INDIANA DEPARTMENT OF TRANSPORTATION

STANDARDS COMMITTEE MEETING

## April 15, 2010 Standards Committee Meeting

RE: Agenda for the April 15, 2010 Standards Committee Meeting

PROPOSED REVISED DRAWING 807-LTHM-03 LIGHTING HIGH MAST POLE CONCRETE PAD

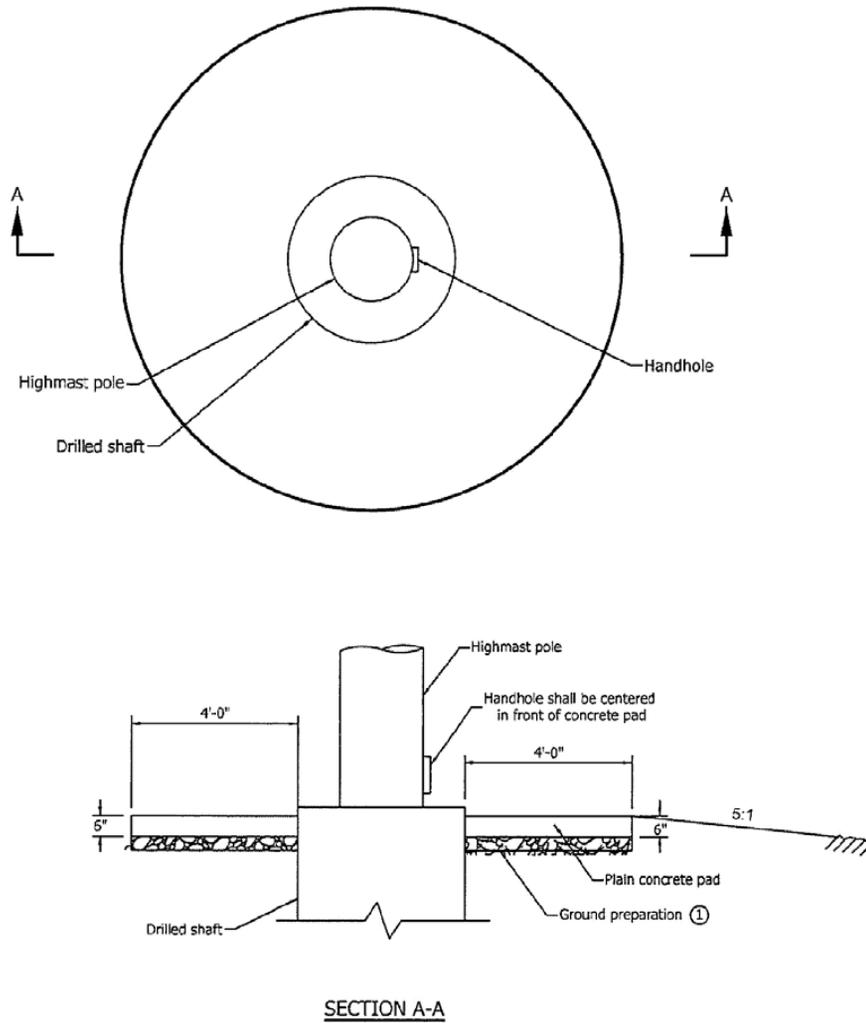
- ① The slope grading around the concrete pad shall be as shown unless otherwise directed.
- 2. See Standard Drawing E 807-LTHM-04 for concrete pad where retaining wall is required.

REVISION TO THE STANDARD DRAWING 616-SWCO-07 SLOPEWALL AND DRAINAGE DETAILS

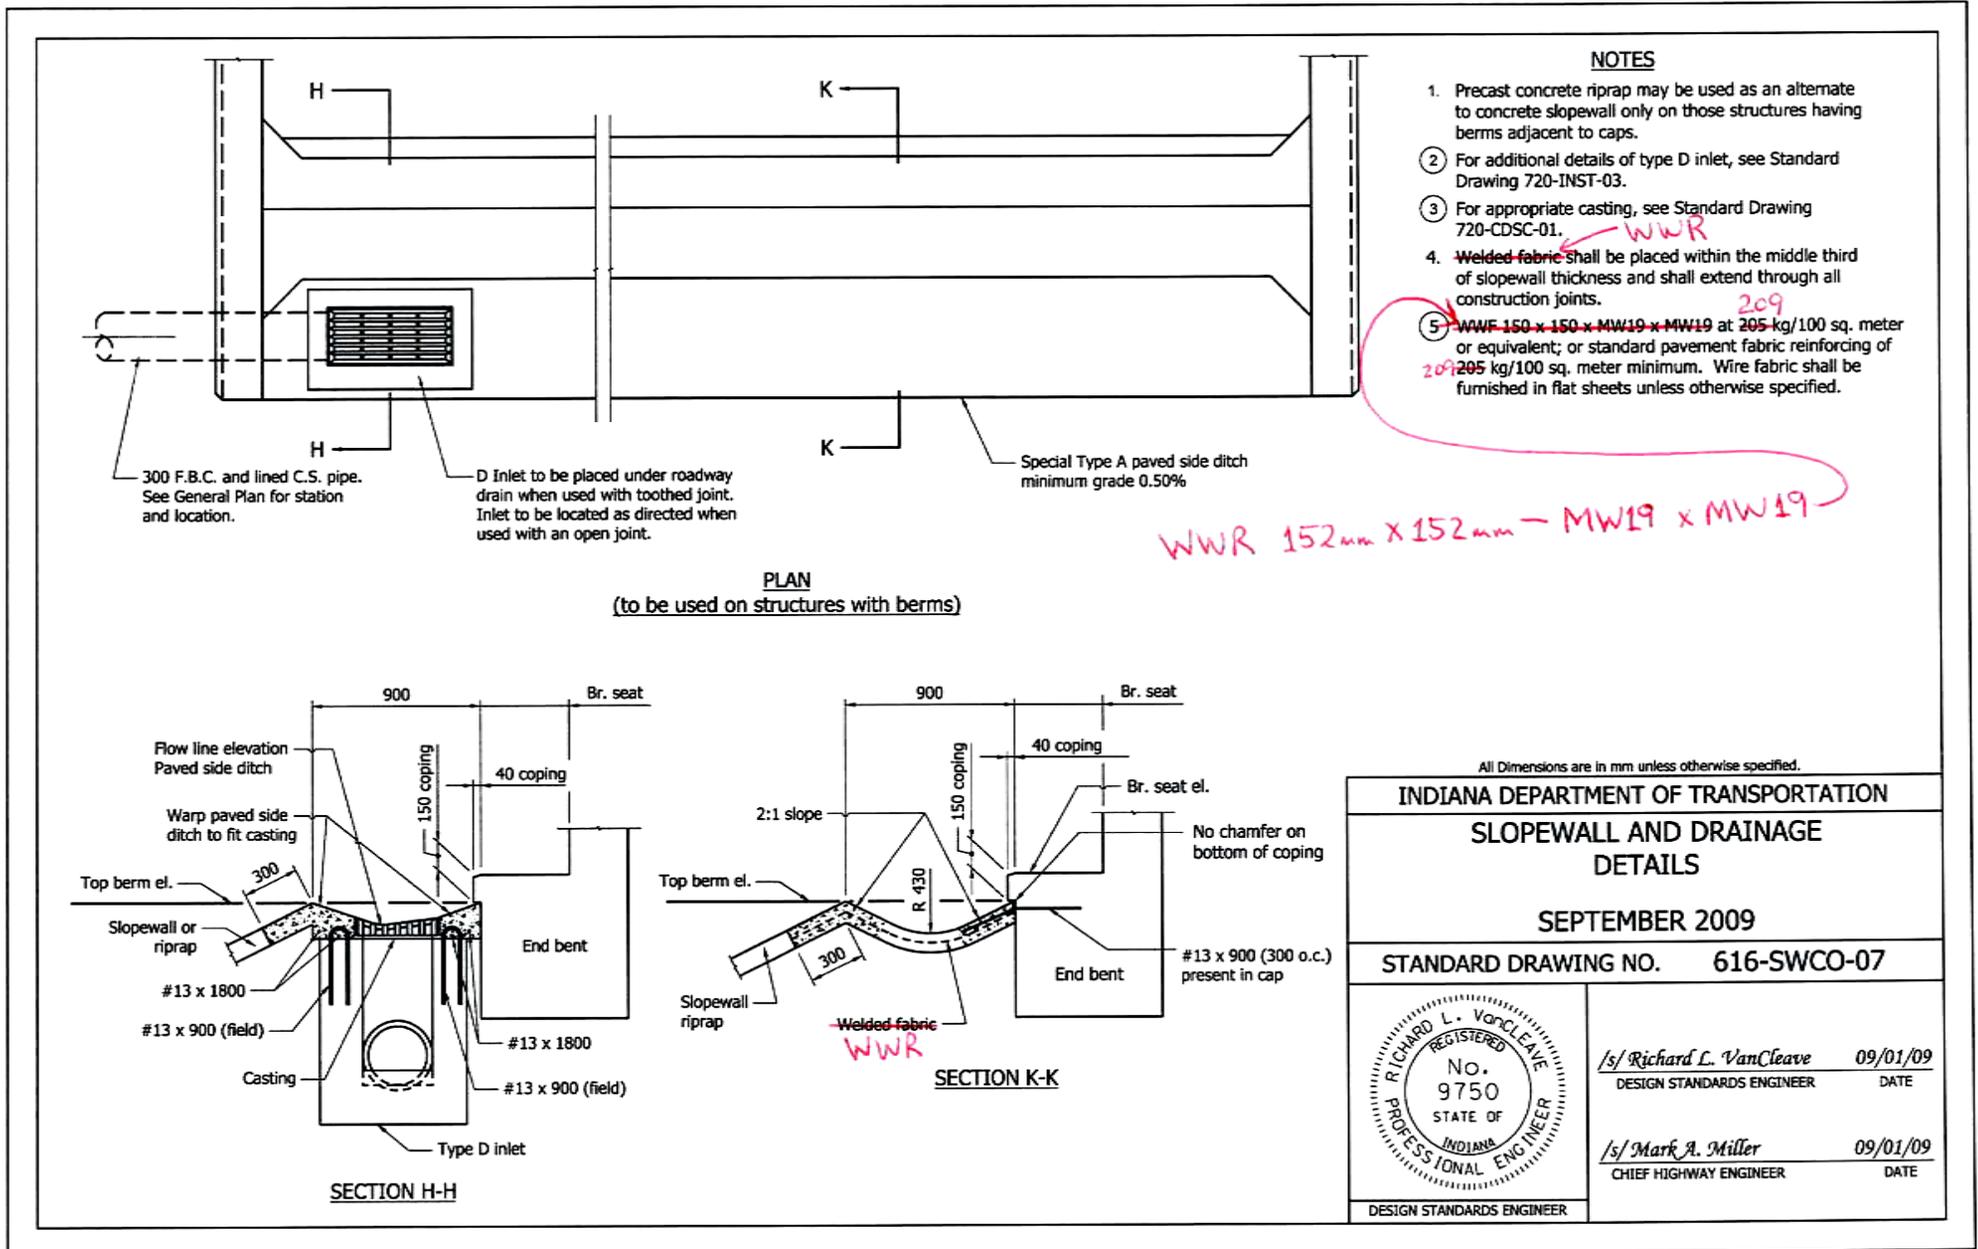
PROPOSED SOLUTION: Delete the WWR style designation from 616 as it is duplicated on the standard drawing 616-SWCO-07. Correct the style designation on this standard drawing.

REVISION TO THE RECURRING SPECIAL PROVISION AND STANDARD DRAWINGS  
 PROPOSED NEW STANDARD DRAWING 714-XXXX-01 BOX CULVERT SCOUR PROTECTION

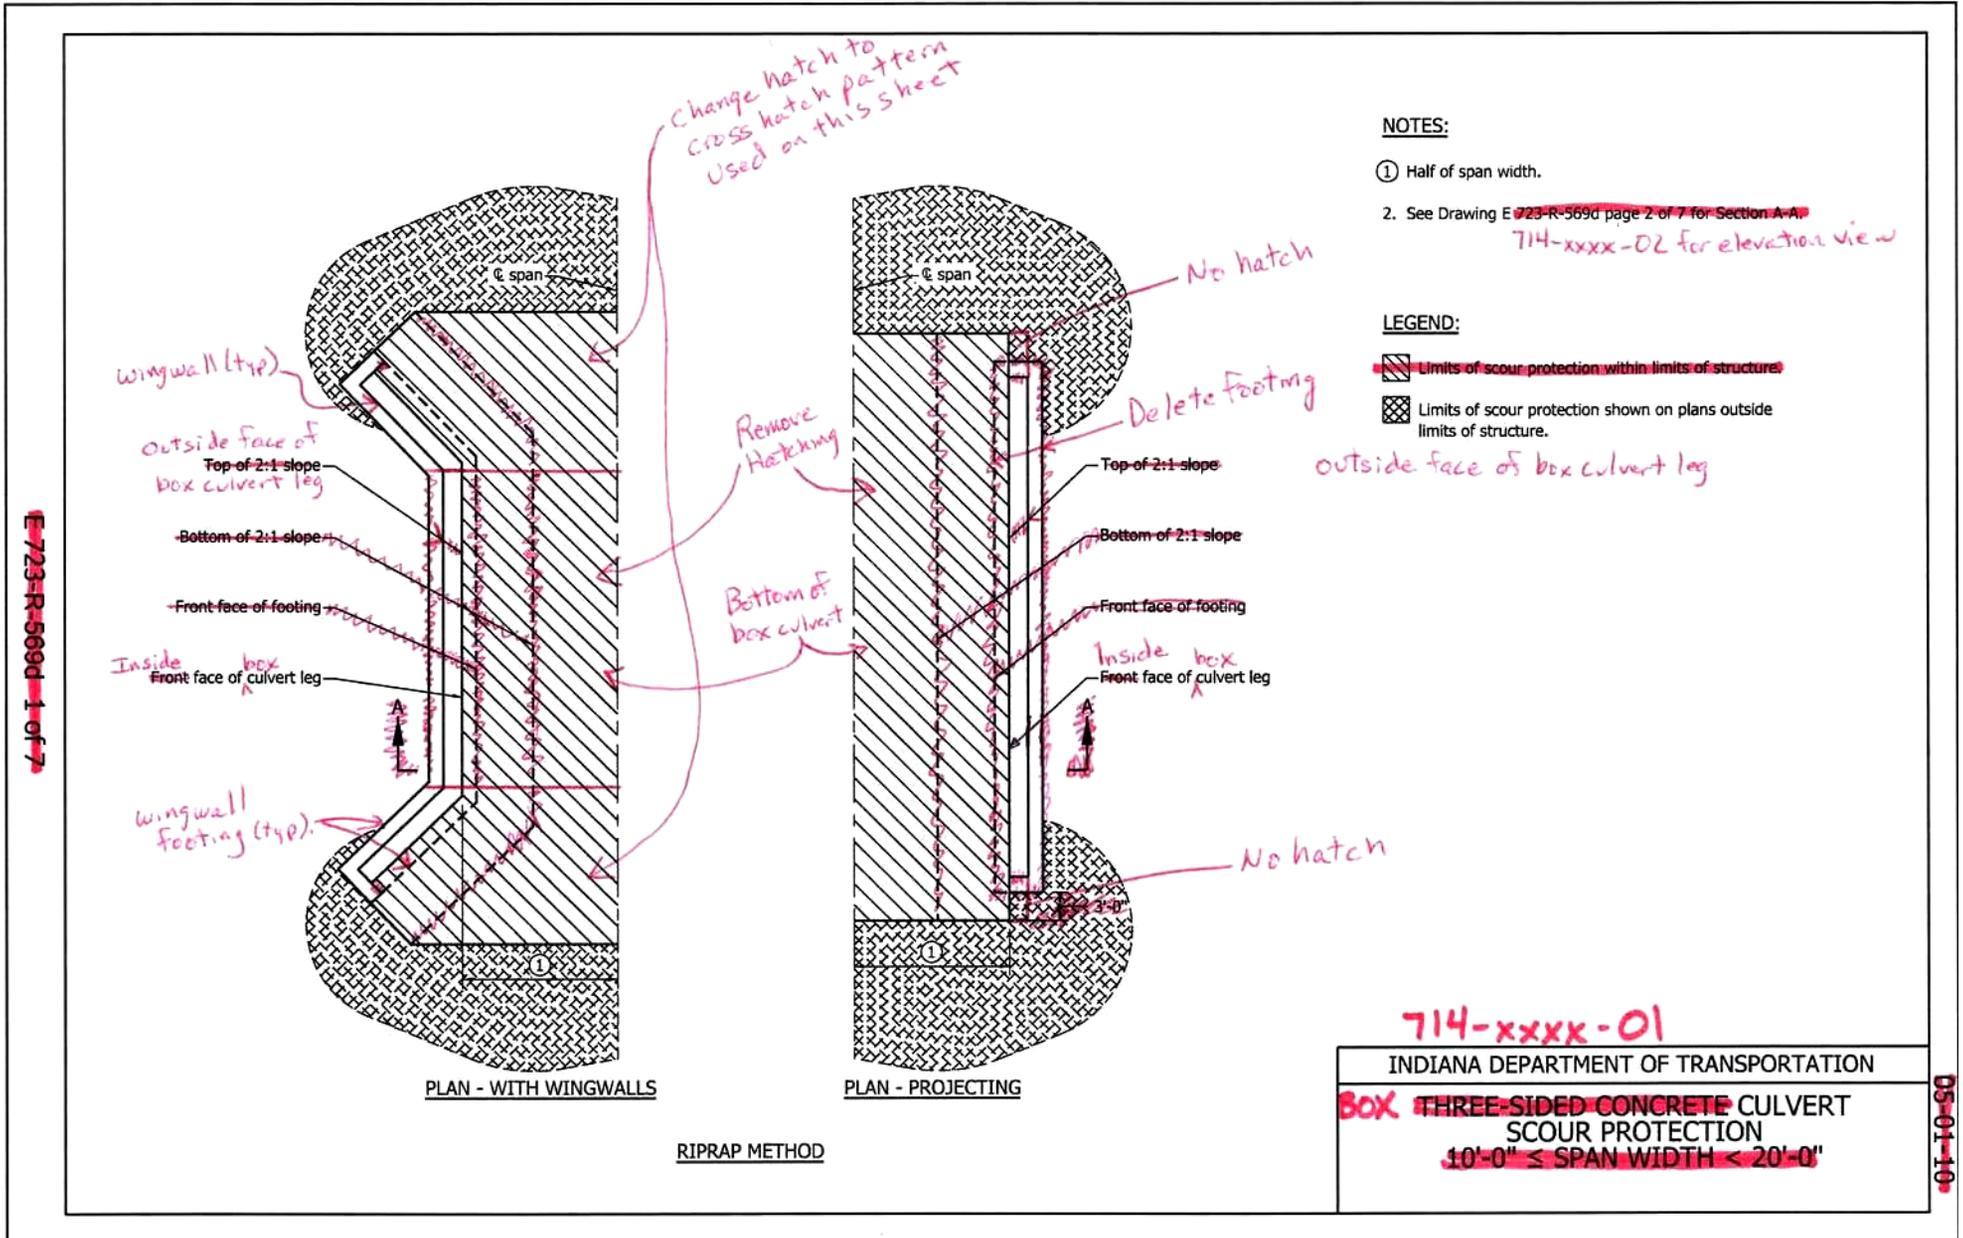
PROPOSED SOLUTION: This item should be considered for passage to follow along with the intent of item 03 from the October 15, 2009 meeting. At the October 15, 2009 meeting scour protection was added to section 723. Committee discussion at this meeting resulted in a consensus comment that this philosophy should be used on the box culverts and pipe structures as well. This proposal makes the necessary adjustments to incorporate scour protection into the 714 and 715 sections.

REVISION TO THE RECURRING SPECIAL PROVISION AND STANDARD DRAWINGS  
 PROPOSED NEW STANDARD DRAWING 714-XXXX-02 BOX CULVERT SUMPING PROTECTION

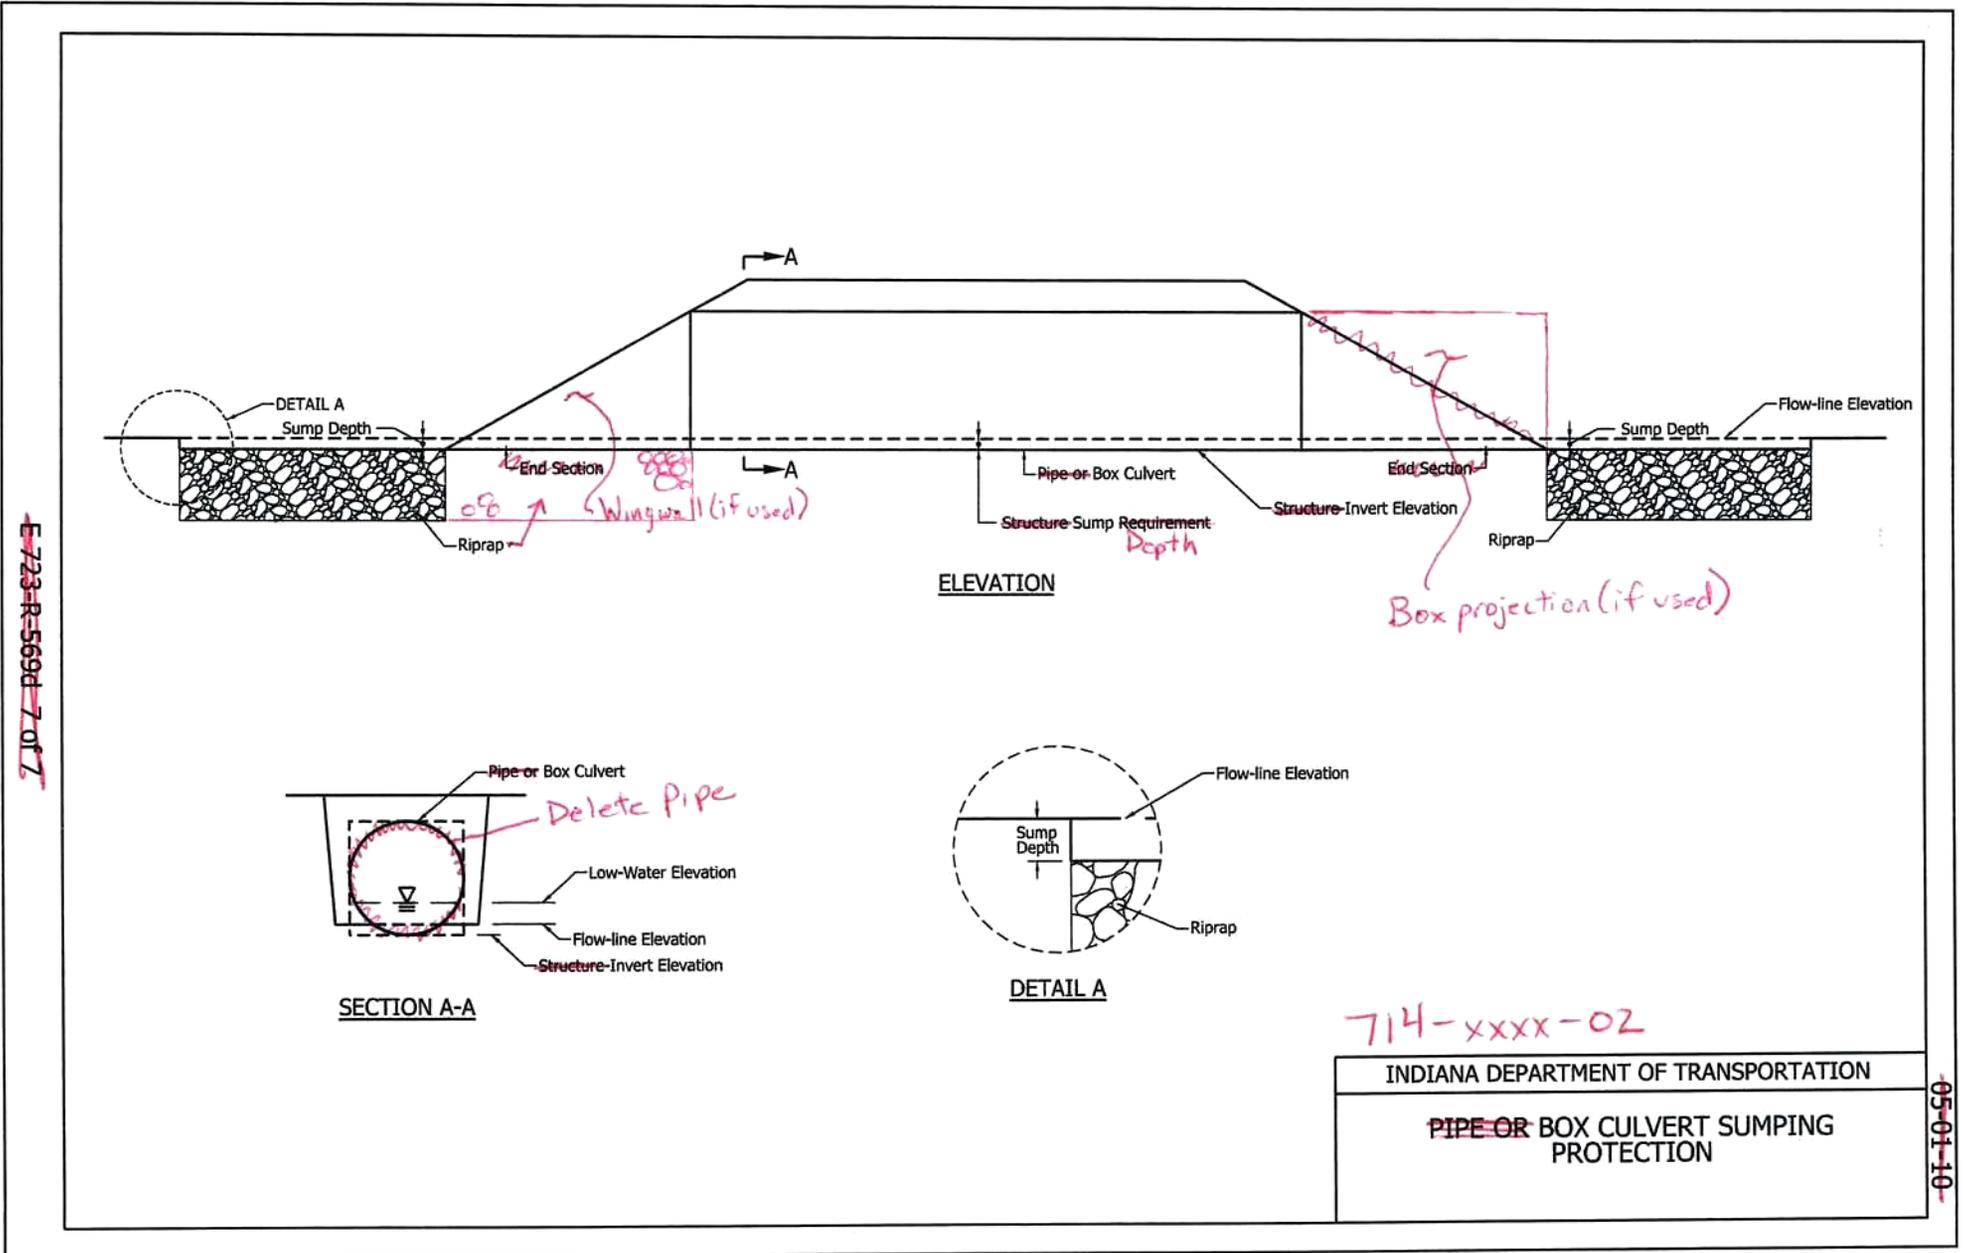
The new standard drawing to show the sump treatment for a pipe culvert, 715-PCSP-01, should be changed to only show the pipe structure and not the box culvert. A similar drawing showing only the box culvert should be created and have a 714 number.

PROPOSED REVISION TO RECURRING PLAN DETAILS 706-B-140d GUARDRAIL  
 TRANSITION, TGS-1 (PAGE 3)

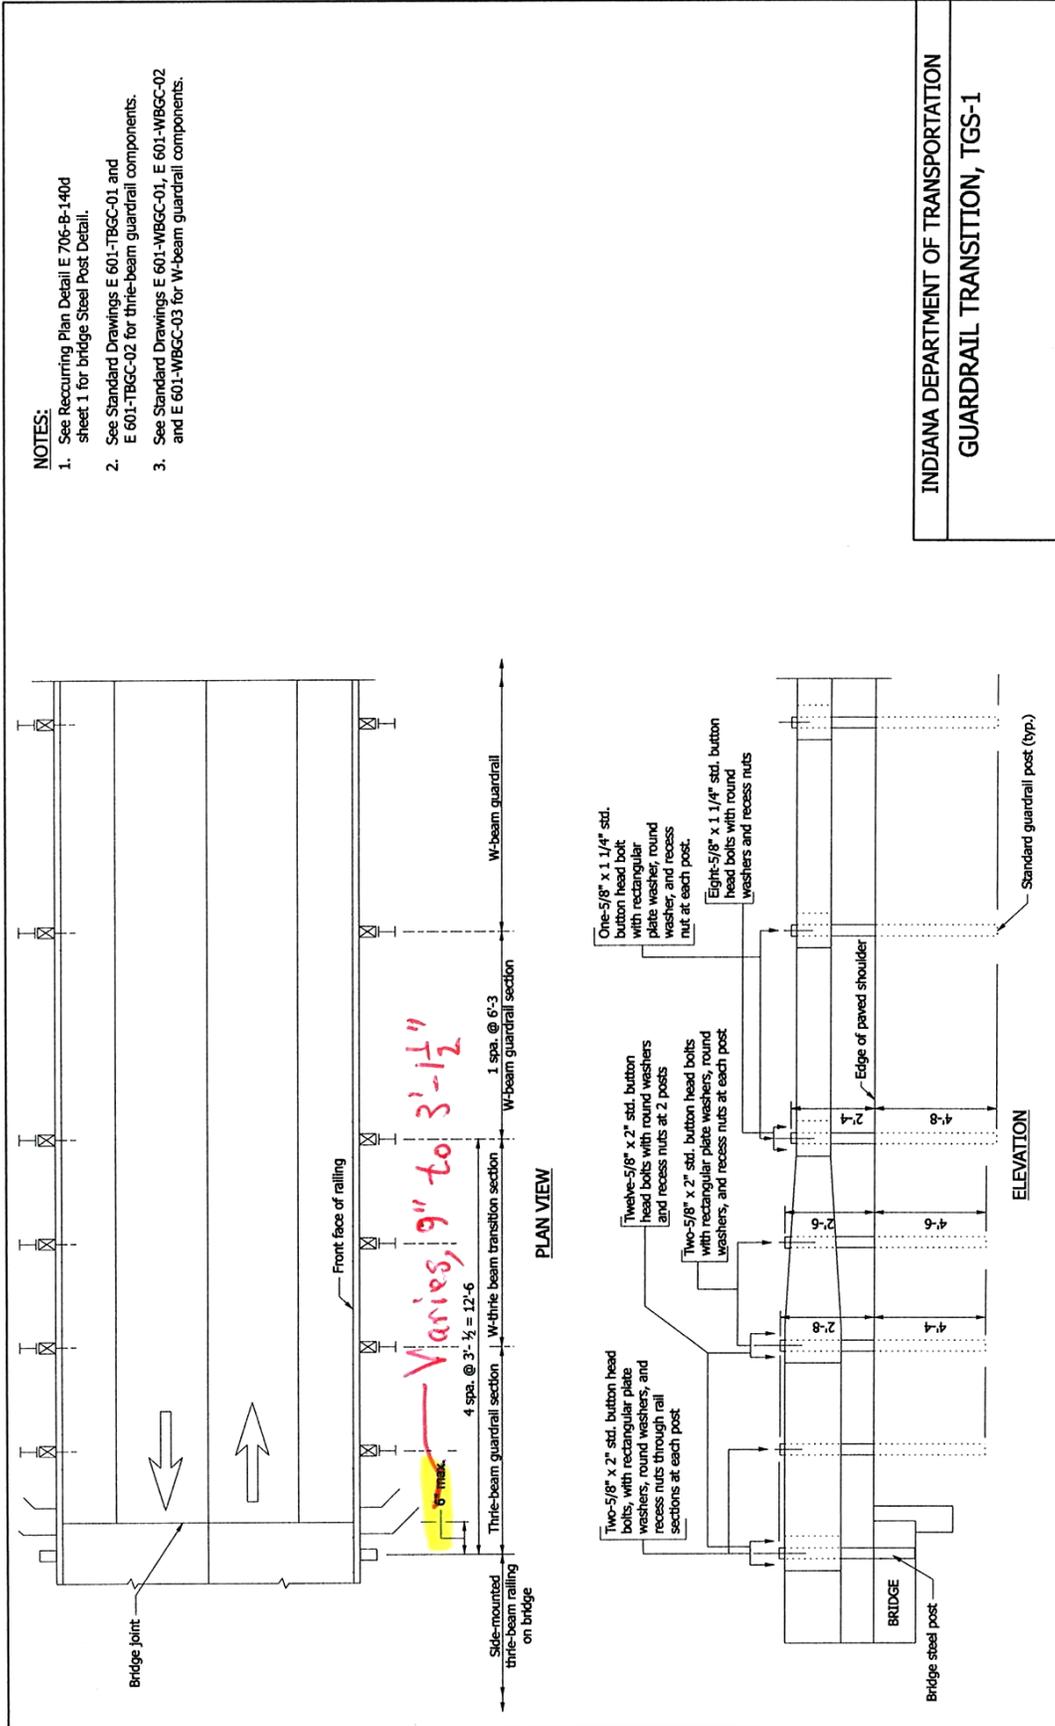
PROBLEM(S) ENCOUNTERED: Guardrail transition TGS-1 approach to a bridge with three-beam side-mounted railing's post spacing is in error. Recurring Plan Detail E 706-B-140d, page 3 of 3, shows the distance from the bridge joint to the first bridge-railing post to be 6 in. maximum. Anchor bolts are required to connect the railing posts to the bridge coping. The bolts must be embedded 2'-10" into the bridge deck. For a structure of greater than 9 deg skew, the inside end of the anchor bolt for the post closest to the joint will penetrate the bridge approach.
